## SYDNEY SOUTH PLANNING PANEL - ASSESSMENT REPORT

<b>Panel Reference</b>	2019SSH010
<b>DA Number</b>	DA-303/2019
<b>LGA</b>	Canterbury Bankstown Council
<b>Proposed Development</b>	Demolition of existing structures, consolidation of lots and construction of a residential flat building (comprising 28 units) pursuant to Division 1 of the State Environmental Planning Policy (Affordable Rental Housing) 2009, basement car parking and associated site works (Crown Development)
<b>Street Address</b>	24-28 Viccliffe Avenue Campsie
<b>Applicant/Owner</b>	Mono Constructions Pty Ltd (On behalf of Land and Housing Corporation)
<b>Date of DA lodgement</b>	22 May 2019
<b>Number of Submissions</b>	7 Submissions
<b>Recommendation</b>	Refusal
<b>Regional Development Criteria (Schedule 7 of the SEPP (State and Regional Development) 2011</b>	Part 4, Clause 20(1) of the SEPP (State and Regional Development) 2011 the application is declared as regionally significant development. Schedule 7 includes 'Crown development over \$5 million'. The proposed capital investment value of \$8,392,277 and falls within this category.

<b>Report date</b>	27 March 2020

**Figure 2** Subject site/s to Bus Stop (Bus Stop ID 219469)

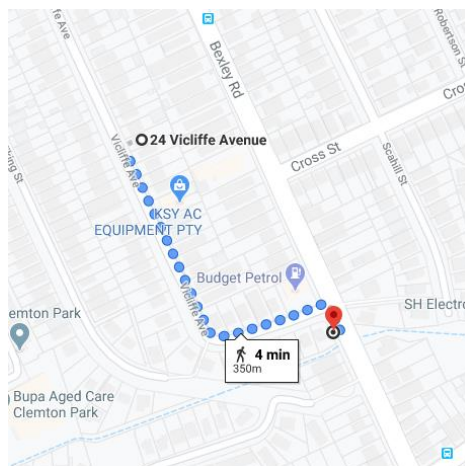
The site is located within 400m walking distance to a bus stop (refer to figure 2 below), that meets the definition of "accessible area" under clause 4 of the ARH SEPP. The application therefore satisfies the requirements of this Clause.

It should be noted that the bus stop nominated on the submitted architectural plans, Drawing No. DA03 Revision 10 is the incorrect bus stop and is not the one that the applicant is relying on to meet the requirements of this Clause. However, we do accept that the site meets the accessible requirements as the Bexley Road Bus stop is within 400 metres walking distance and meets the required bus service times as specified in Clause 4(1)(c) of the ARH SEPP.

Proposed shadow diagram June 21 at 9am (compliant building height outlined in pencil).

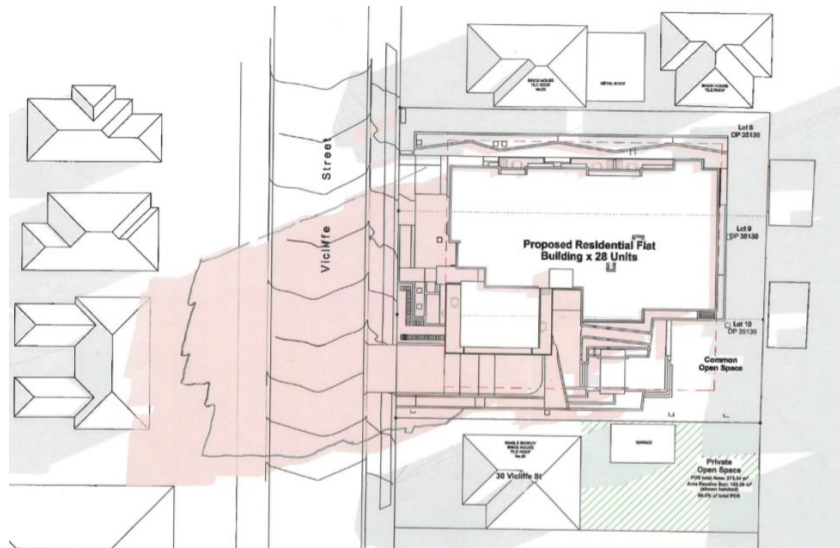
The proposed building height breach will result in shadows reaching the semi-detached dwellings to the western side of Viccliffe (at 51-53 Viccliffe Avenue). The shadow impacts from the proposal extend onto the front open spaces of these properties, as well as the front wall of the building which contain a number of living windows. As, outlined in the shadow diagrams further in this report, a compliant building will only shadow a portion of the front yard of 51-53 Viccliffe Avenue and will have no impact to the front façade and living room windows to these properties. The applicant has not addressed the impacts of the overshadowing to these dwellings.
